SUBJECT: Underground Storage Tank Closure Assessment for Fisher-Hamilton  
Scientific, 1316 18th St., Two Rivers, WI 54241

SUBJECT: Underground Storage Tank Closure Assessment for Fisher-Hamilton Scientific, 1316 18th St., Two Rivers, WI 54241

**Site Assessment  
and  
Tank Closure Report**

Site Map

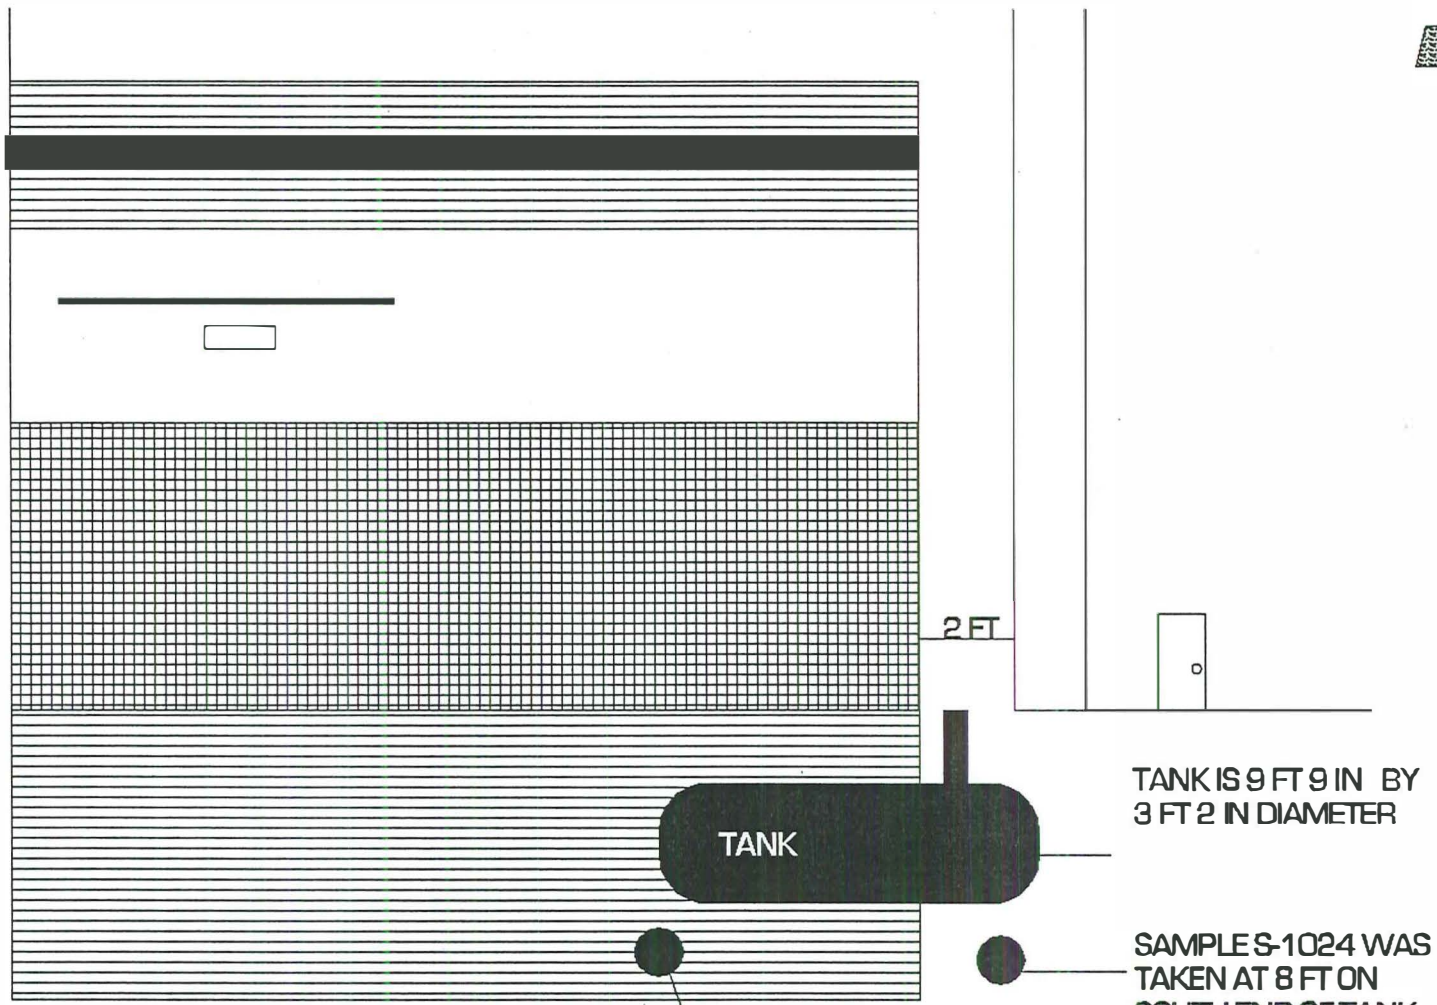
1. An accurate site map showing the locations of the soil samples in relationship to the other structures on the site (building, driveways) and the former locations of the tanks, pumps, and piping;
2. Copies of the lab results and sample chain-of-custody;
3. A narrative describing the following the date and time the samples were conducted, the name, address, and phone number of the firm conducting the borings, the name of the person collecting the samples, soil types encountered and any other relevant information; and
4. If borings are used to collect the samples, copies of the soil boring logs and borehole abandonment forms completed in accordance with NR 141, Wis. Admin. Code.

The samples were taken on either end of the now removed underground tank at a depth greater than the original tank removal excavation. The soil sampled was undistributed native alluvial sand. Sampling was done in the presence of Bill Lantz a registered State of Wisconsin, Professional Engineer. Terry Freudenrich was the site assessor, IHLR Certification 00859. Sampling location drawings attached.
